SERVICE AND APPLICATION NOTES

H-09-3

ECB40-12.5CB and ECB40-15CB Electric Heat Circuit Breaker Wiring Issue

FIGURE 1

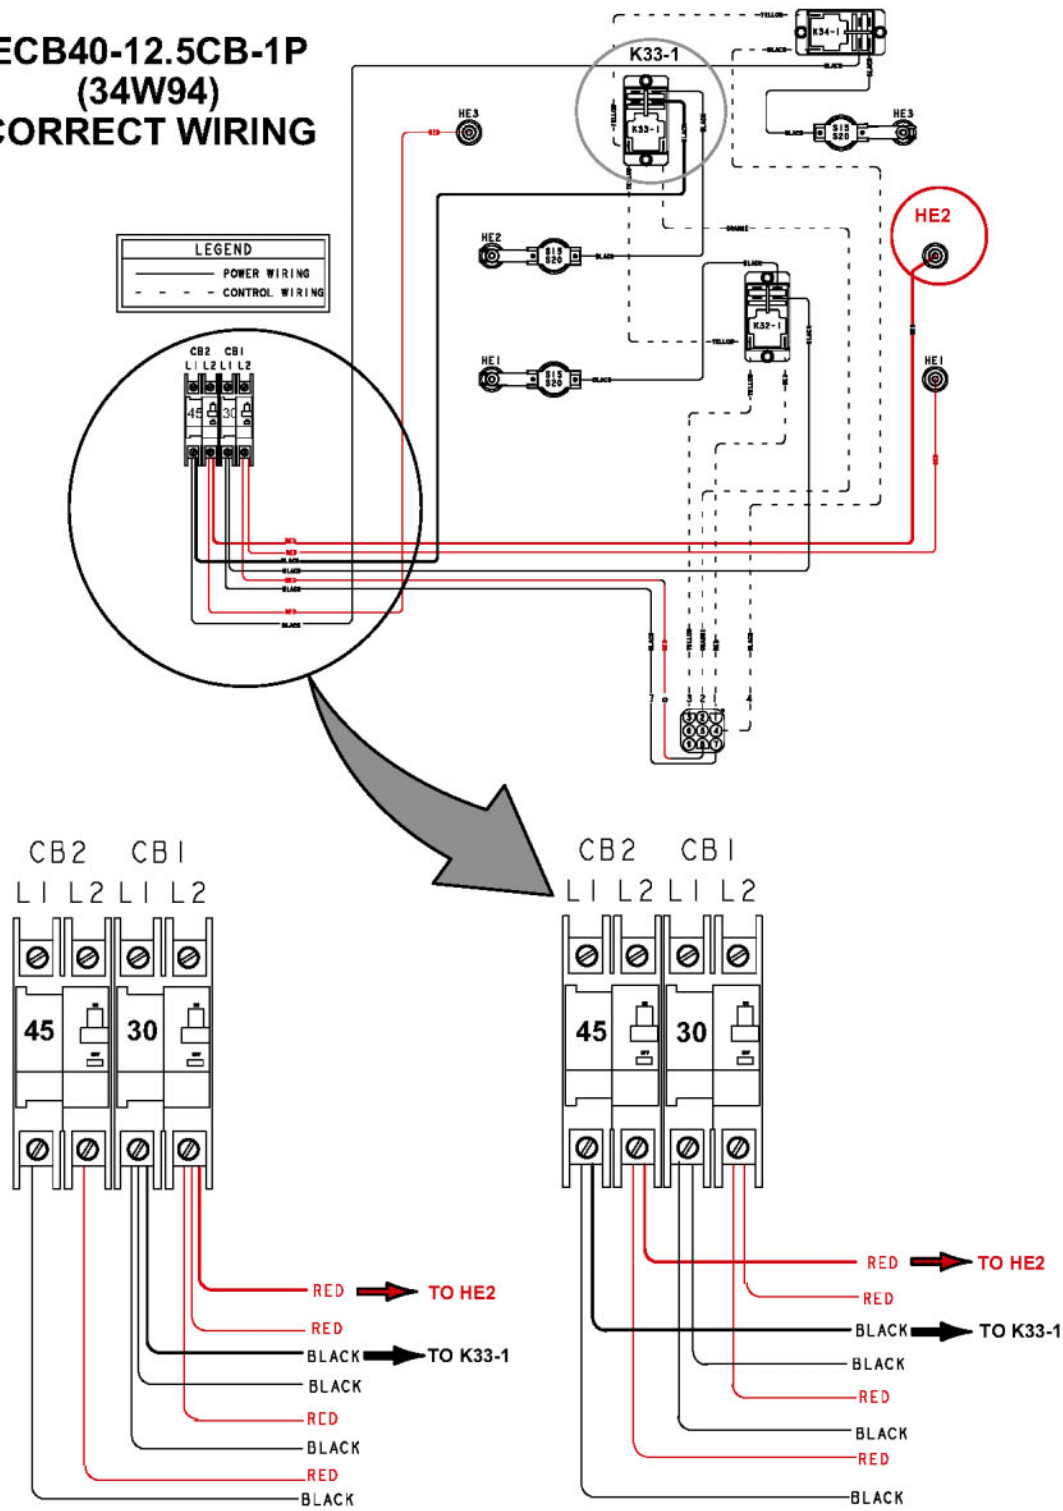
ECB40-12.5CB - Has two breakers (30 and 45 AMP)

Incorrect Wiring:

The 30 AMP circuit breaker electric heat section has elements HE1 and HE2 plus the plug in for the control board on this circuit. The 45 AMP circuit breaker has the element HE3 on this circuit.

Correct Wiring:

The 30-AMP circuit breaker should have the element HE1 and the plug in for the control board. The 45 AMP circuit breaker should have elements HE2 and HE3 on this circuit.

Field Corrective Action: Verify correct high voltage circuit breaker wiring from each element. See figures 1 and 2.

FIGURE 2

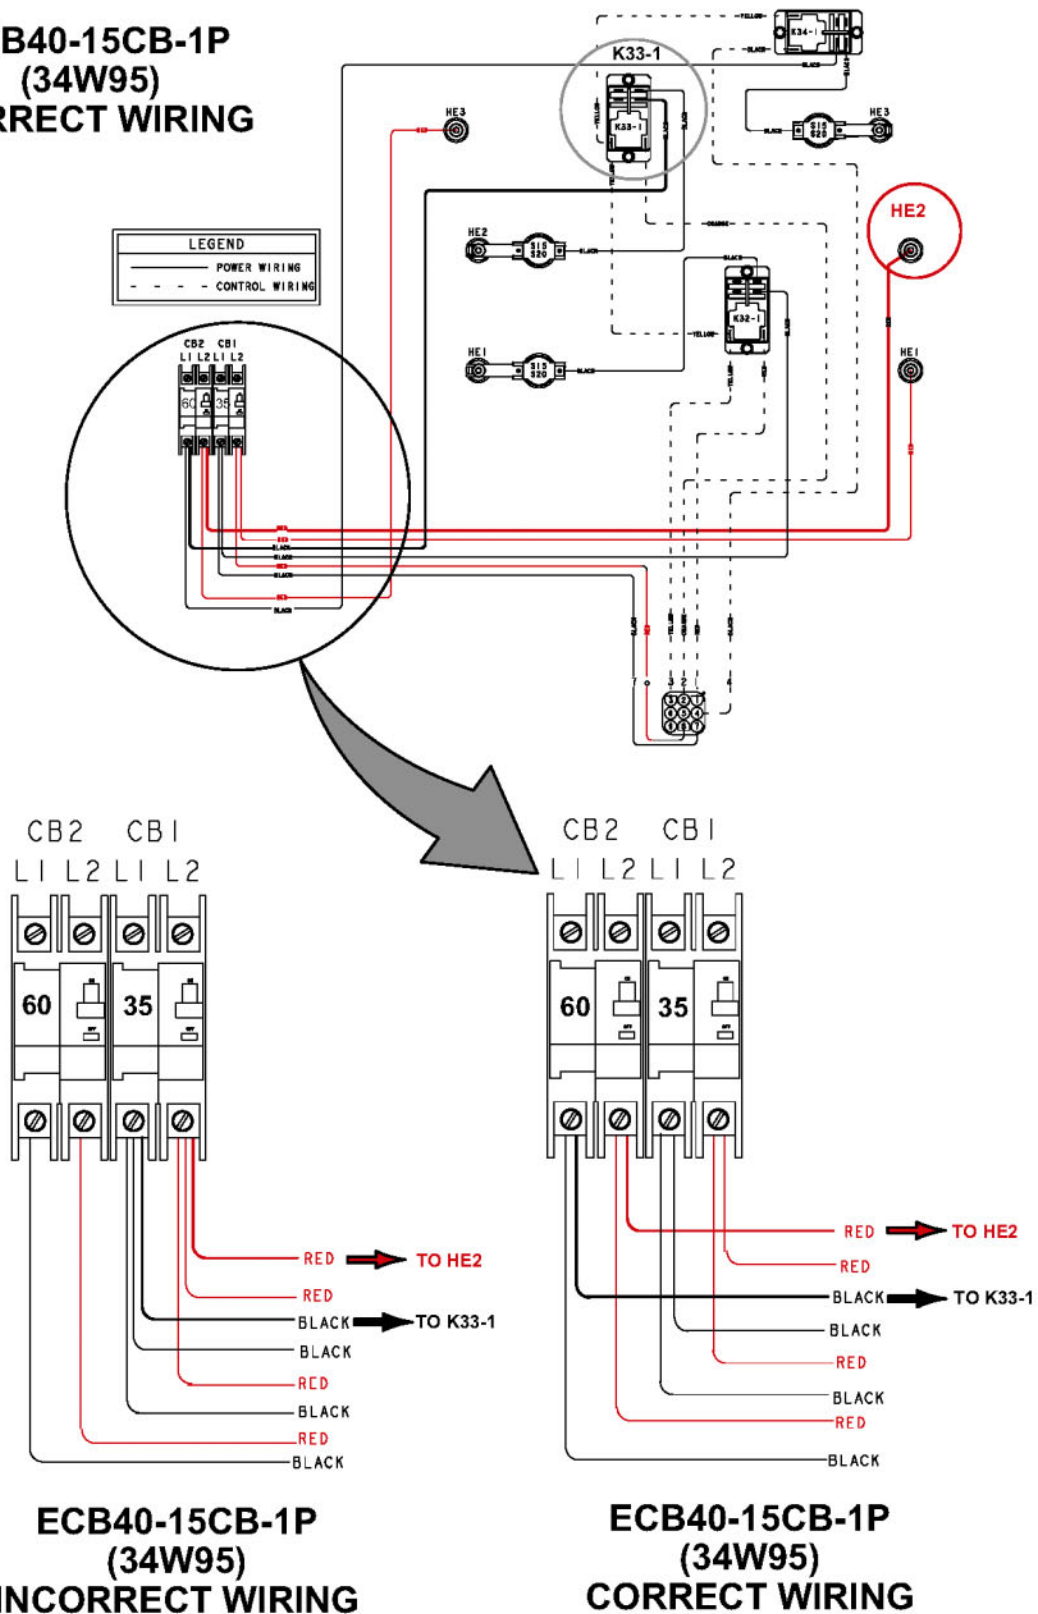
ECB40-15CB - Has two breakers (35 and 60 AMP)

Incorrect Wiring: The 35 AMP circuit breaker has elements HE1 and HE2 plus the plug in for the control board on this circuit. The 60 AMP circuit breaker has elements HE2 and HE3 on this circuit.

Correct Wiring: The 35 AMP circuit breaker should have element HE1 and the plug in for the control board.

The 60 AMP circuit breaker should have elements HE2 and HE3 on this circuit.
